FIRST FINANCIAL BANK - SHELBYVILLE, IN
ADDENDUM C
ELECTRICAL RISER DIAGRAM
 ELECTRICAL SERVICE CLARIFICATION

DWG.BY: SCR	DATE: 3/5/10	SHEET NO: E203
CHK.BY: SCR	SCALE: NTS	
CAD NO: 9681E203	PROJ.NO: 9681.00

ELECTRIC & TELEPHONE SERVICE RISER DIAGRAM
 N.T.S.

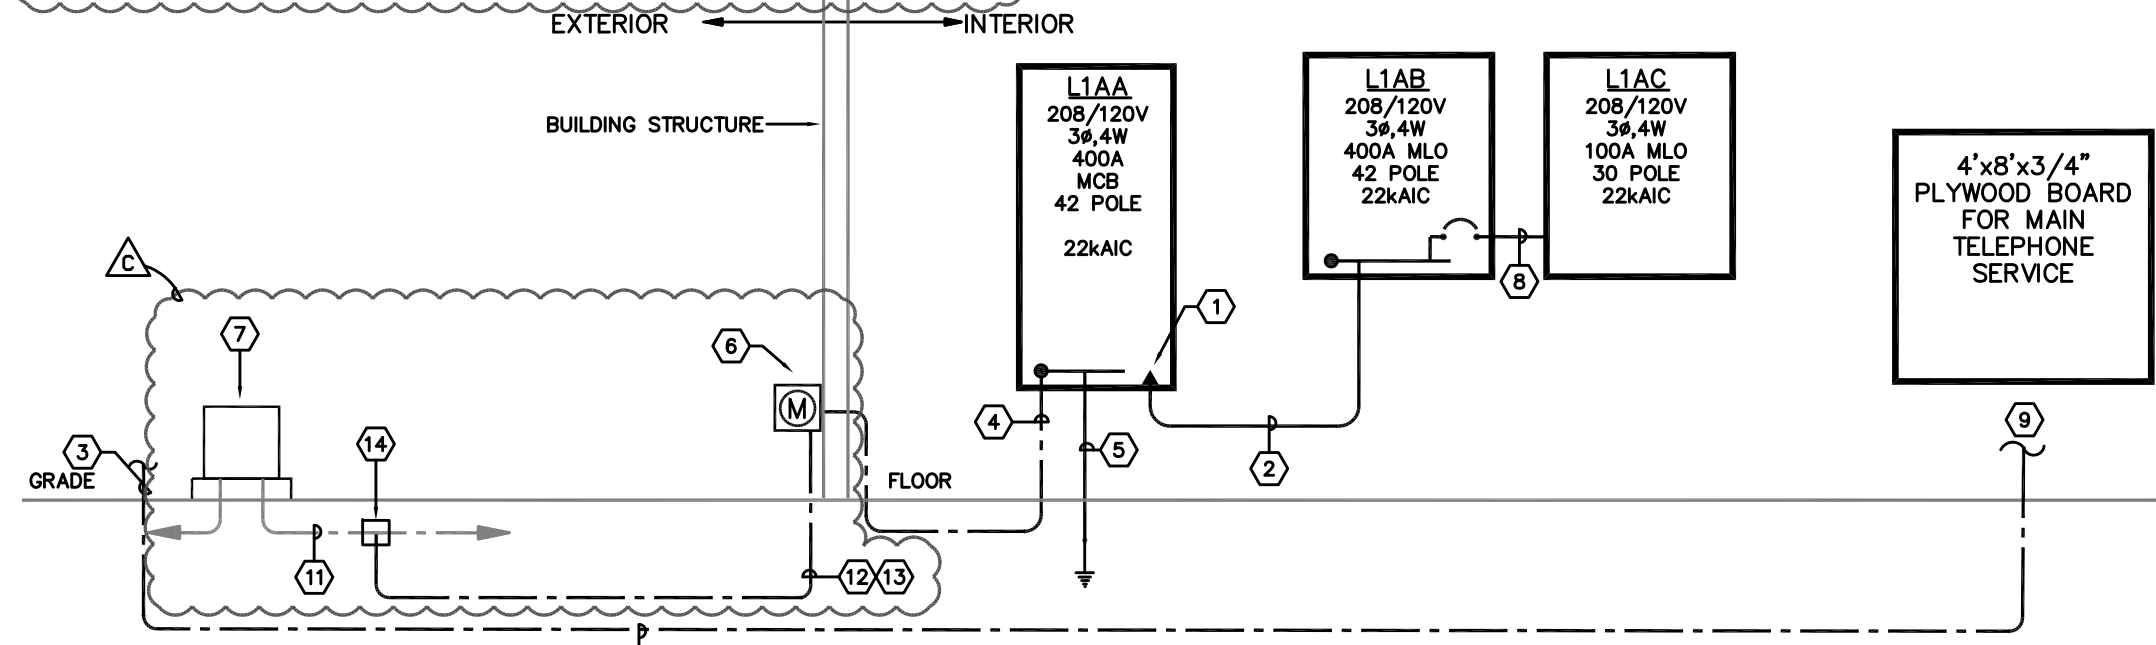
- ⚡ RISER DIAGRAM CODED NOTES:**
1. PROVIDE SUB-FEED LUGS KIT IN PANEL L1AA TO SUB-FEED PANEL L1AB.
 2. PROVIDE (2) SETS OF (4)#3/0 CU, (1)#4 AWG CU GND. IN 2" CONDUIT EACH.

3. COORDINATE WITH TELEPHONE/CABLE COMPANY.
 4. PROVIDE 2 SETS (4)#3/0 CU, IN 2" SCH 40 PVC CONDUIT EACH. REFER TO NOTE #12.
 5. PROVIDE 3/4"x10' (1)#1/0 CU. GND. TO GROUND ROD.

6. ELECTRICAL CONTRACTOR SHALL PROVIDE SELF CONTAINED 400A LEVER BYPASS METER BASE. DUKE ENERGY SHALL PROVIDE ELECTRIC METER.
 7. PAD MOUNTED TRANSFORMER BY UTILITY COMPANY ON LOT #2.

8. PROVIDE (4)#2 AWG CU, (1)#8 AWG CU GND. IN 1-1/4" CONDUIT.
 9. STUB 6" ABOVE FINISHED FLOOR.
 10. PROVIDE (2) 4" EMPTY CONDUITS FOR MAIN TELEPHONE SERVICE.

11. EXISTING UTILITY COMPANY CONDUIT INFRASTRUCTURE ALONG MARKETPLACE BOULEVARD.
 12. PROVIDE (2) 4" CONDUITS FROM METER BASE TO DUKE ENERGY PROVIDED HAND HOLE ALONG SOUTHEAST CORNER OF LOT BETWEEN LOT#1 (FFB) AND LOT#2 FOR CONNECTION TO UTILITY COMPANY CONDUITS. COORDINATE ALL WORK WITH DUKE ENERGY. REFER TO SITE PLAN ES100 FOR MORE INFORMATION.

13. DUKE ENERGY SHALL PROVIDE FEEDER CONDUCTORS FROM UTILITY TRANSFORMER ON LOT #2, THROUGH HAND HOLE, TO ELECTRICAL UTILITY METER ON BUILDING.
 14. DUKE ENERGY PROVIDED HAND HOLE.

ELECTRIC UTILITY COORDINATION:
 ELECTRICAL CONTRACTOR AWARDED THE CONTRACT SHALL REQUEST AN ENGINEERING APPOINTMENT WITH RICK BUTLER TO COORDINATE THE LOCATION OF CONNECTION BETWEEN THE (2) 4" CONDUITS FROM THE METER BASE TO DUKE ENERGY'S PROVIDED HAND HOLE ALONG THE SOUTHEAST CORNER OF THE PROPERTY PRIOR TO PERFORMING ANY UNDERGROUND UTILITY WORK. THE ENGINEER APPOINTMENT REQUEST SHALL BE MADE BY CALLING 1-800-774-0246.
